ADDENDUM NUMBER ONE

DATE OF ISSUANCE: August 16, 2019 **PROJECT NUMBER:** 19028

PROJECT: Snowbasin Clinic
3925 Snow Basin Road
Huntsville, Utah 84317 **ARCHITECT:** JRCA Architects, Inc.
577 South 200 East
Salt Lake City, Utah 84111

MECHANICAL ADDENDUM 1

A3
DP101 DEMO MAIN LEVEL FLOOR PLAN
SCALE 1/8" = 1'-0"

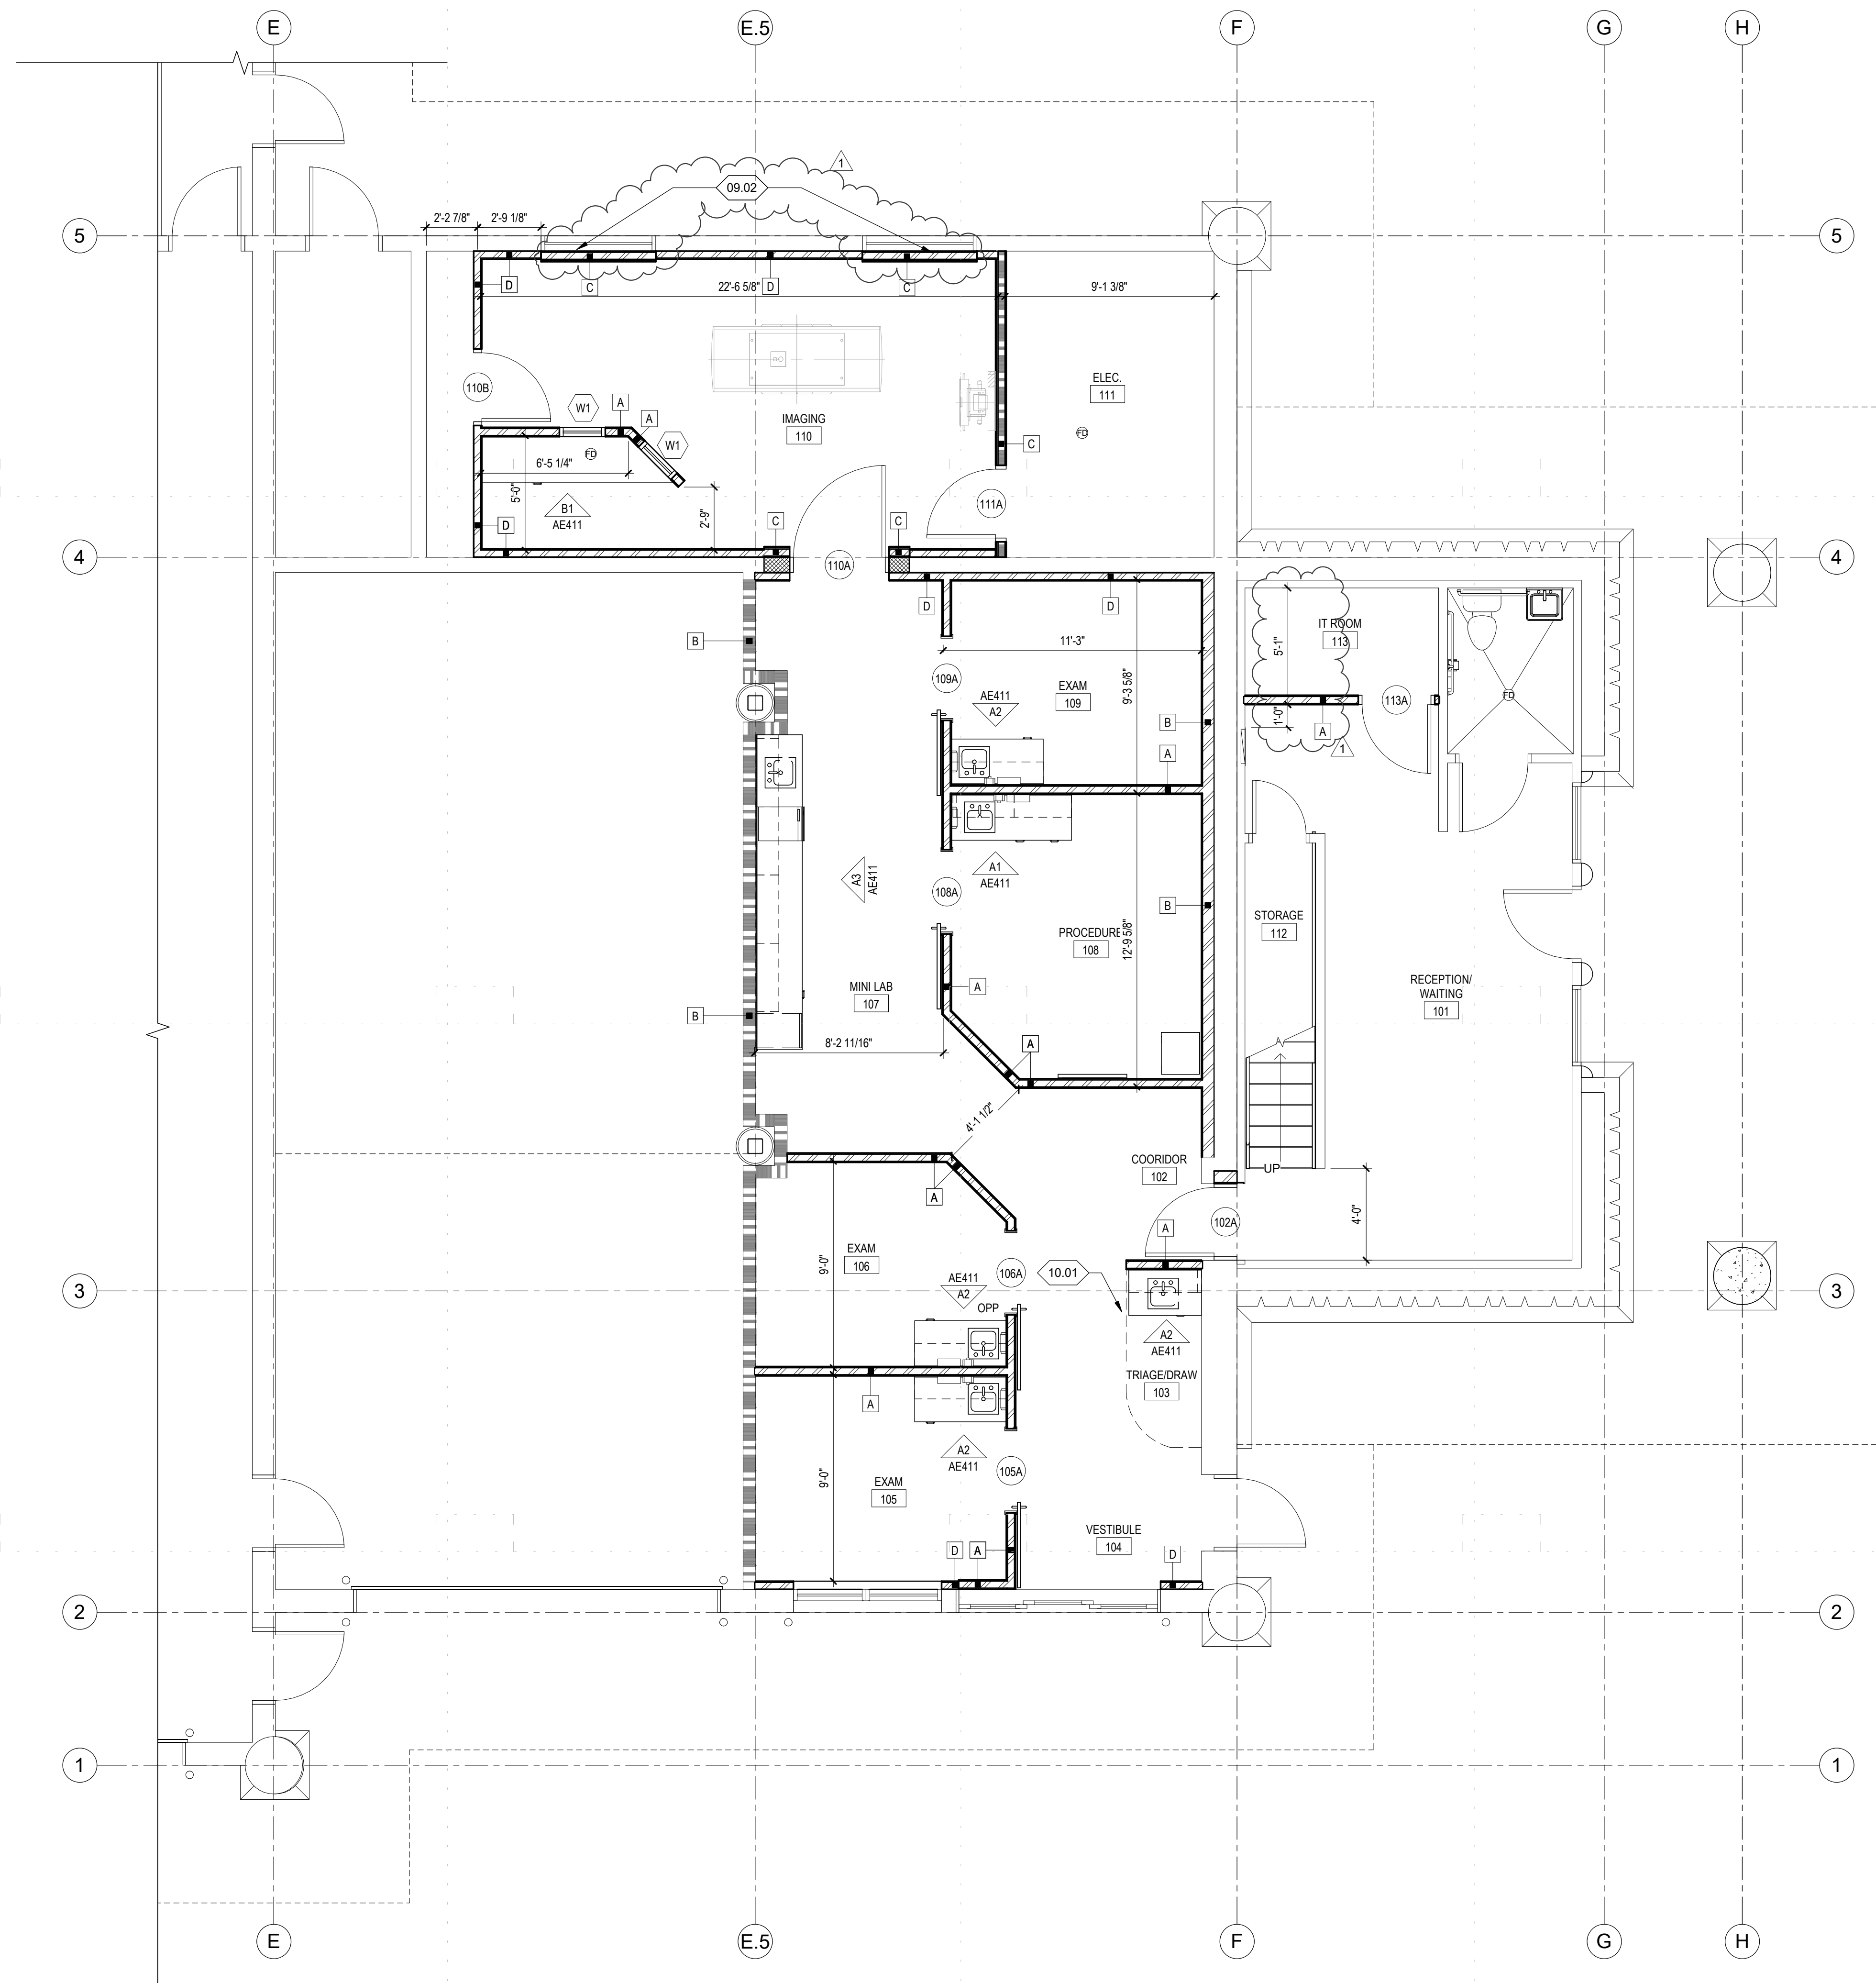
| <u>Item No.</u> | <u>Section or Sheet No.</u> | <u>Description</u> |
|-----------------|-----------------------------|---|
| AD1-6 | DP101 | See demo plan indicating demo of any existing ceilings that will require access for new ceiling or MEP equipment. |

| Key Value | Keynote Text |
|-----------|--|
| 02.01 | DEMO ALL EXISTING CEILING WITHIN SPACE FOR ACCESS TO FLOOR JOISTS ABOVE AS NEEDED. |

A4 FLOOR PLAN
AE101 SCALE 1/4" = 1'-0"

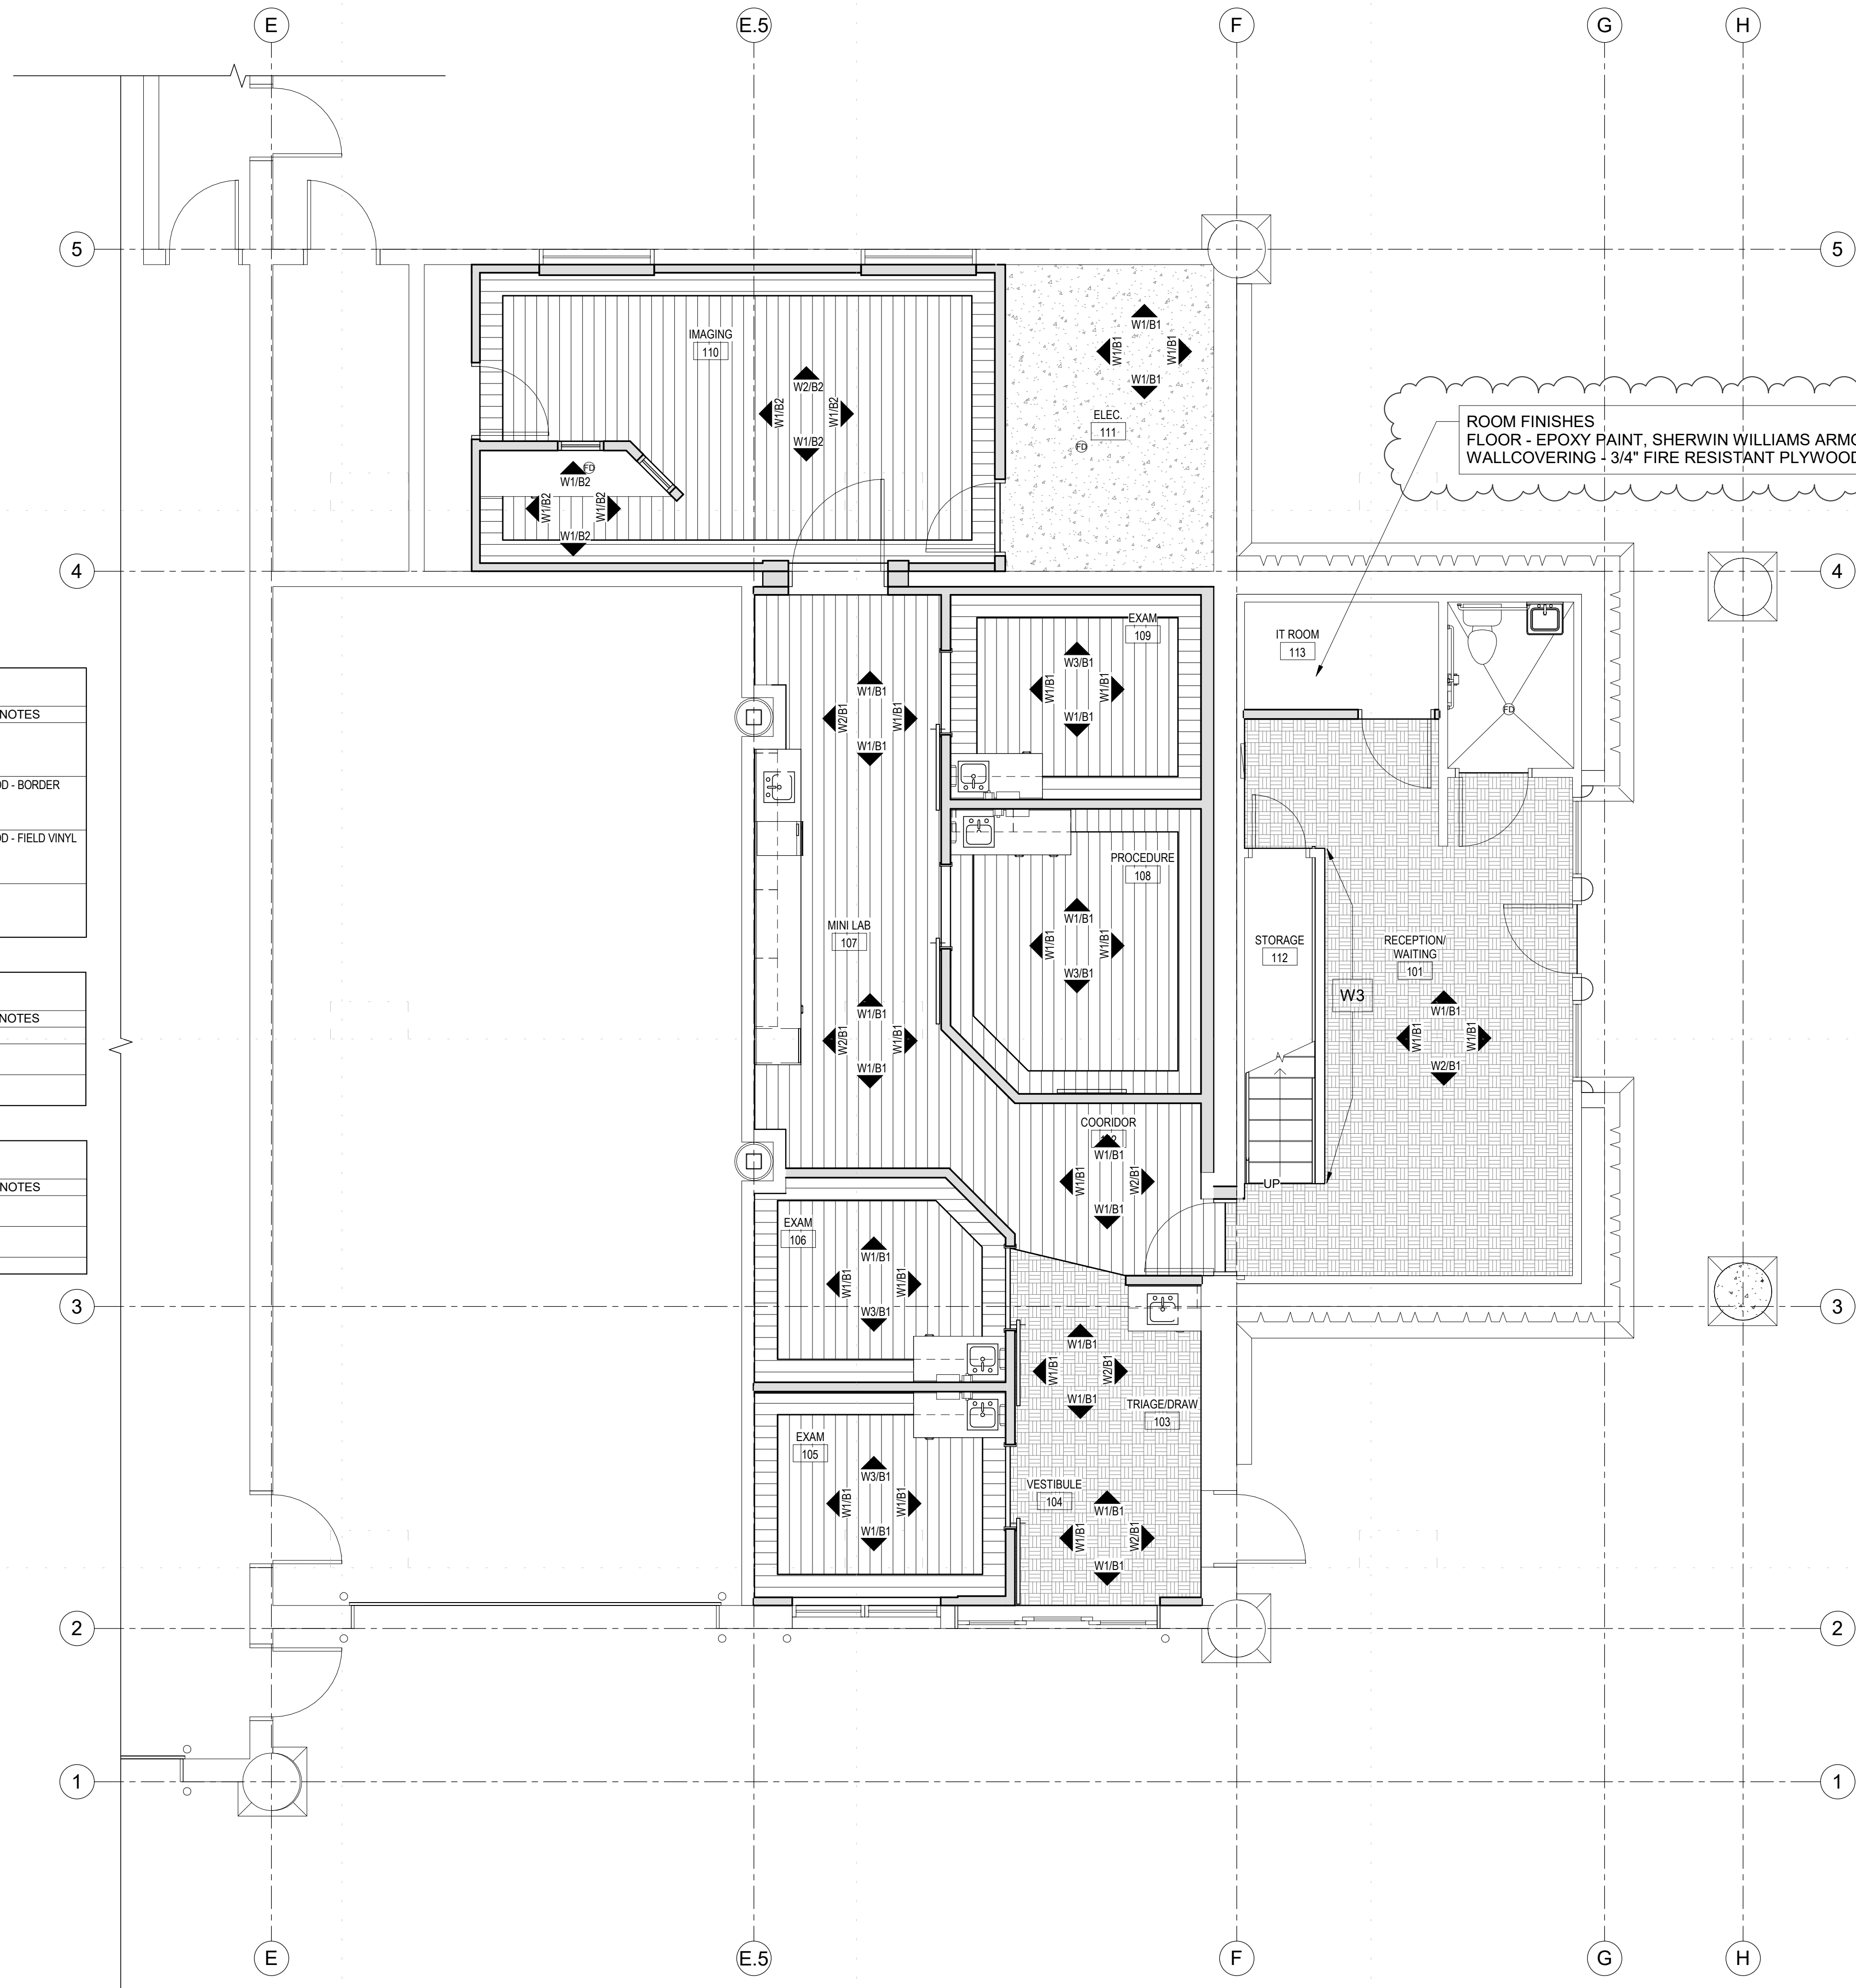
| <u>Item No.</u> | <u>Section or Sheet No.</u> | <u>Description</u> |
|-----------------|-----------------------------|---|
| AD1-7 | AE101 | See updated plan for wall type in IT room. |

A4 MAIN FLOOR FINISH PLAN
 AE121 SCALE 1/4" = 1'-0"

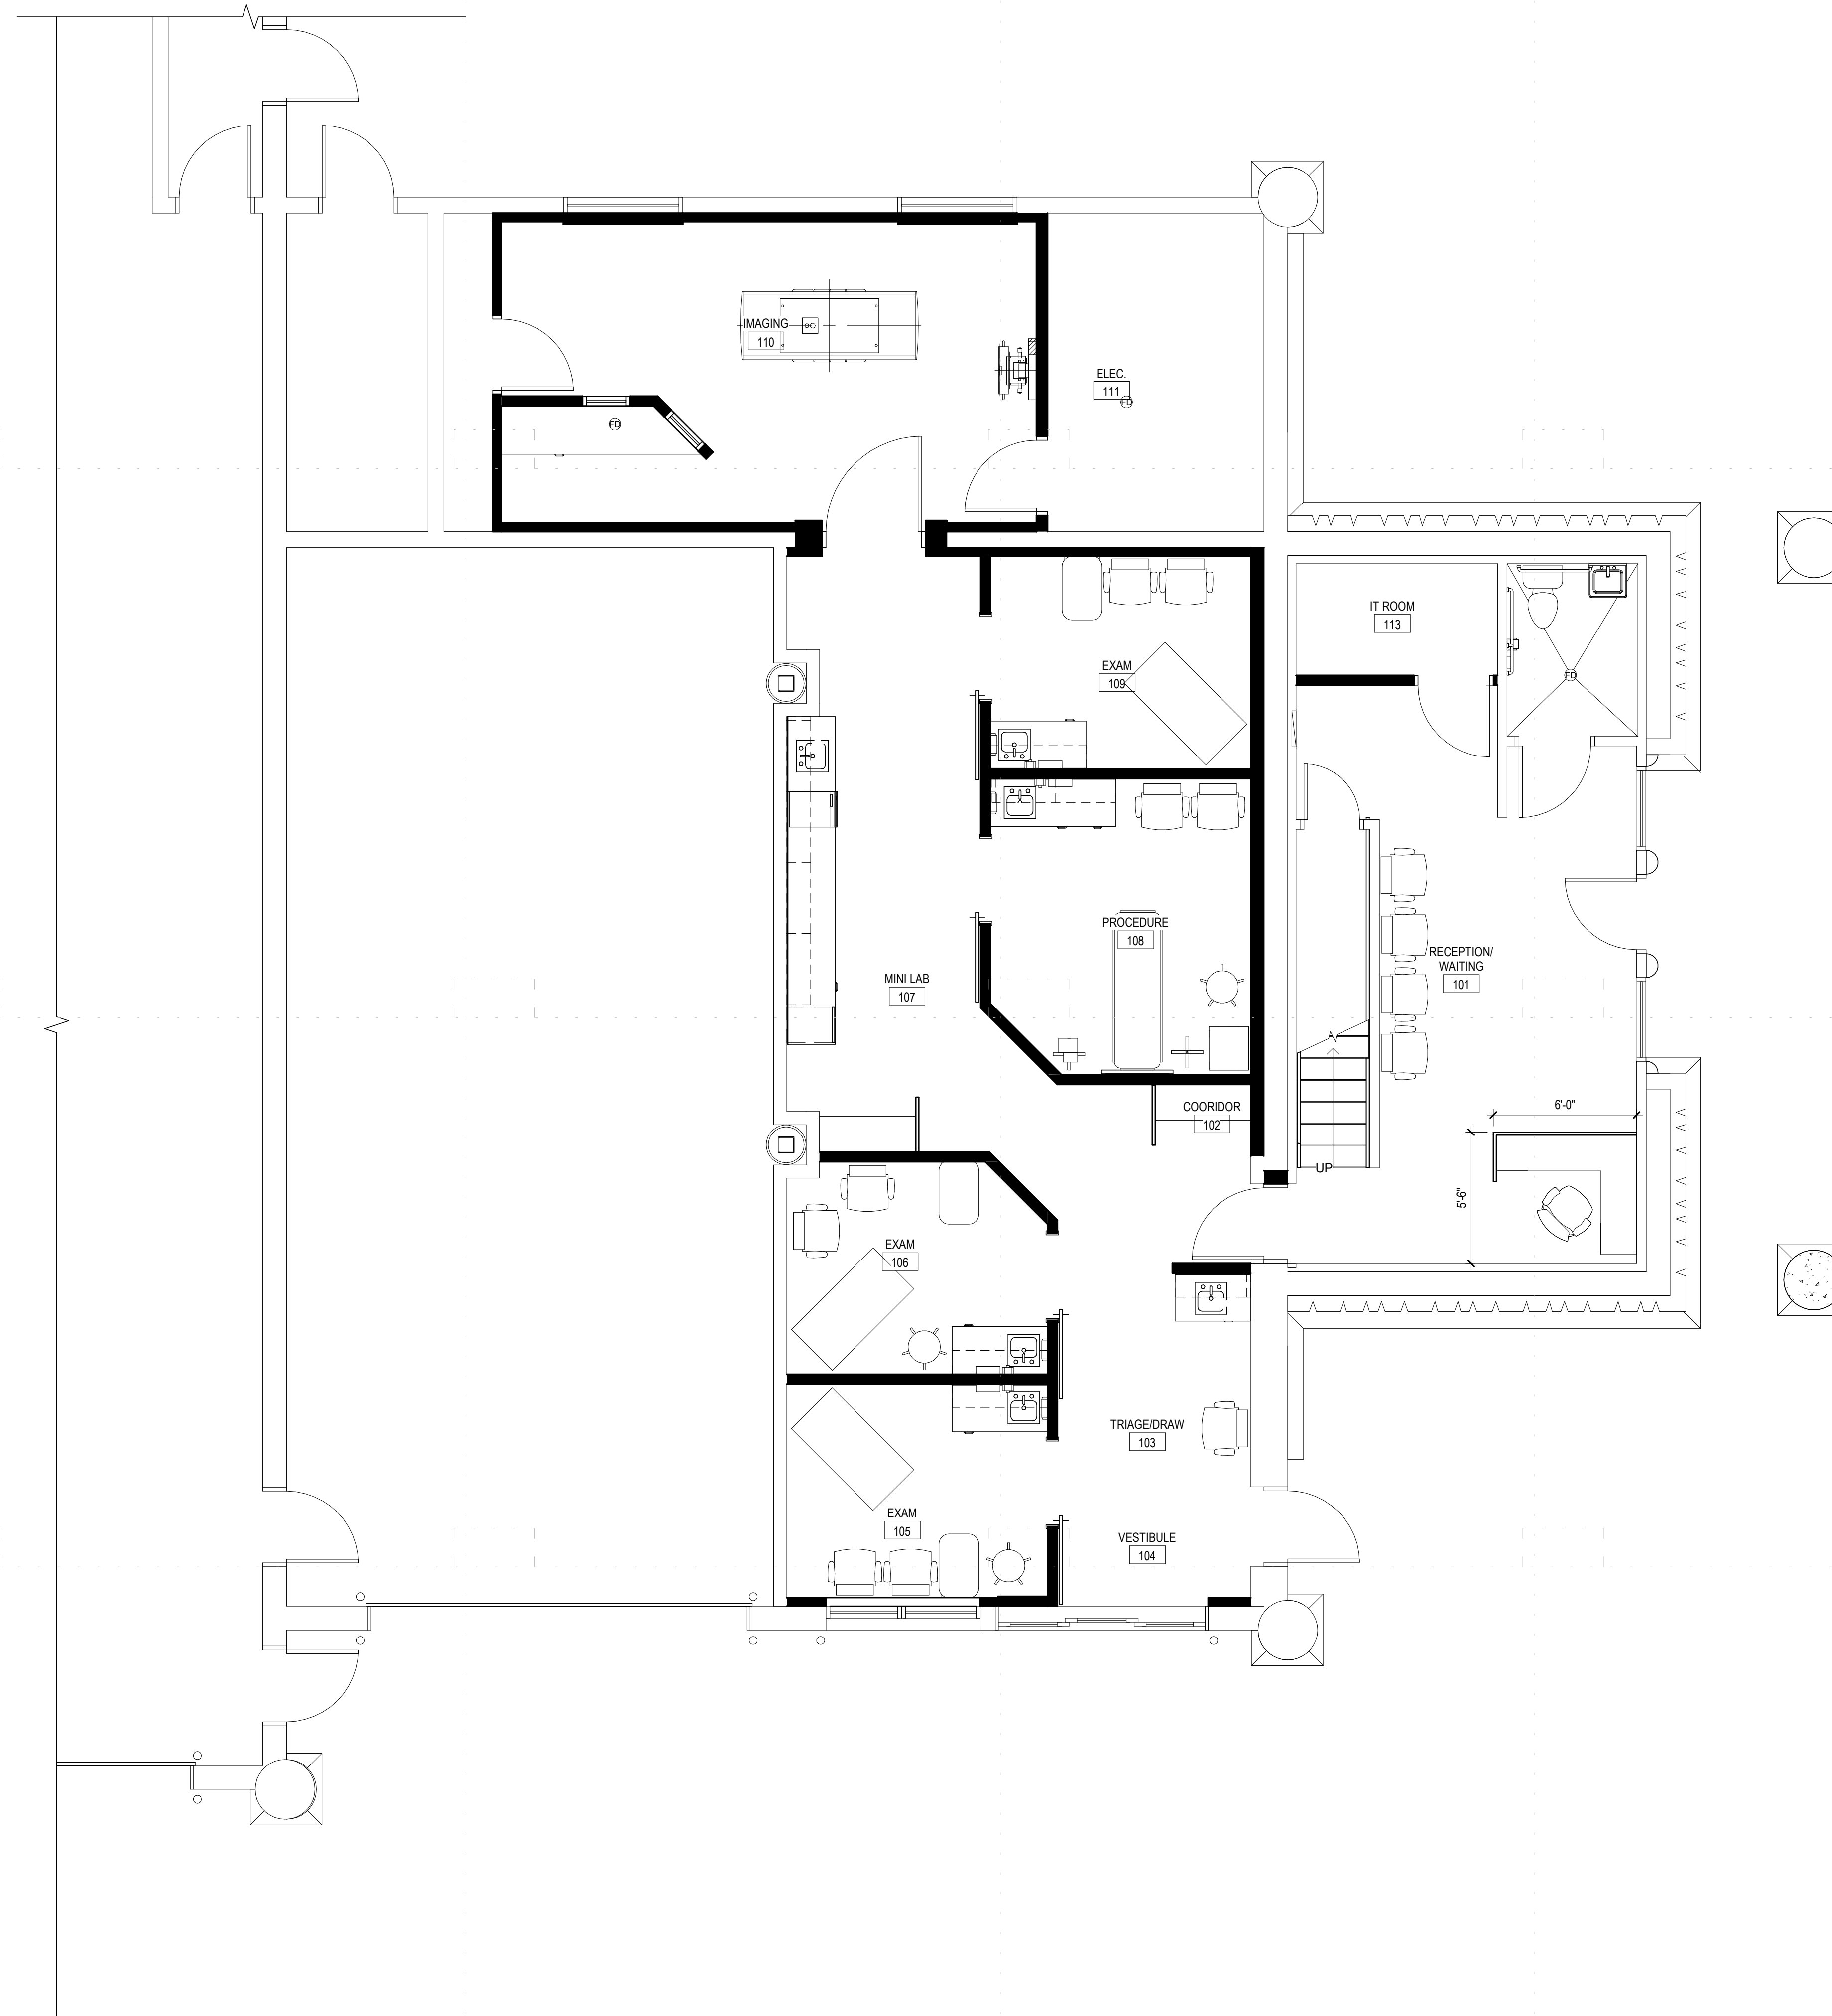
| AD1-8 | AE121 | See updated plan for specific finishes in IT room. |
